Committee Amendment Form November 16, 2009

CDP-09-17

BeltLine Master Plan: Subarea 7 (Northside/Peachtree/Piedmont)

1. Remove the proposed spur trail along Peachtree Creek from Colonial Homes apartments to Peachtree Park Drive from the maps on pages 12, 14, 2-11, 4-3, 4-11, 6-3.
2. On Page 6-5: Remove project M-3 (spur trail along Peachtree Creek) from the table.
3. On page 2-3: On conceptual building plan, add a note that current city regulations prohibit redevelopment within the floodplain similar to the text on page 2-6 and 4-10.
4. Remove the new street from Colonial Homes Drive to Biscayne Drive from the maps on pages 2-9, 2-11, 3-3 and similar maps.
5. Add a new street from Colonial Homes Circle to Biscayne Drive to the maps on pages 2-9, 2-11, 3-3 and similar maps. (This new street shall occur as part of a voluntary, private redevelopment if or when redevelopment ever occurs.)

Trail Alignment through the Armour-Ottley Industrial Area

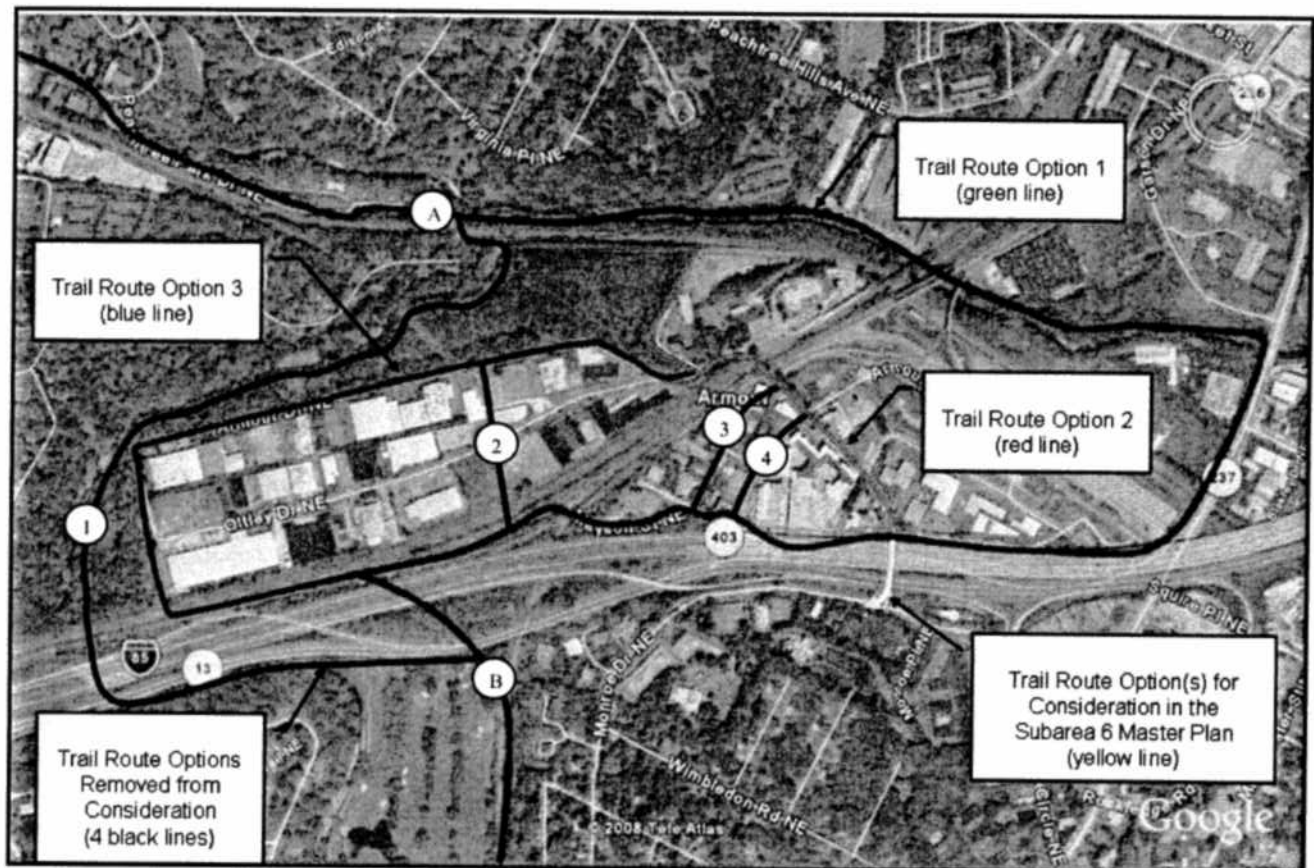
These three are identified in trails section of the plan and are indicated on the figure below by the green, red, and blue lines. The figure also illustrates four route options that were considered, but ultimately removed as recommended route options.

Four options were removed from consideration during the master planning process. All four are illustrated in the figure above by a black line, and numbered 1 through 4. The following table outlines the background and reasons each of the alignment options was dropped from consideration.

The BeltLine Master Plan for Subarea 6 will explore additional trail options that avoid the Norfolk-Southern "Y" crossing Buford Highway and the interstate. Illustrated on the figure above by the yellow line, the trail could run under I-85 and Buford Highway along Armour Drive, make its way through the Monroe Crescent and Peachtree Hills
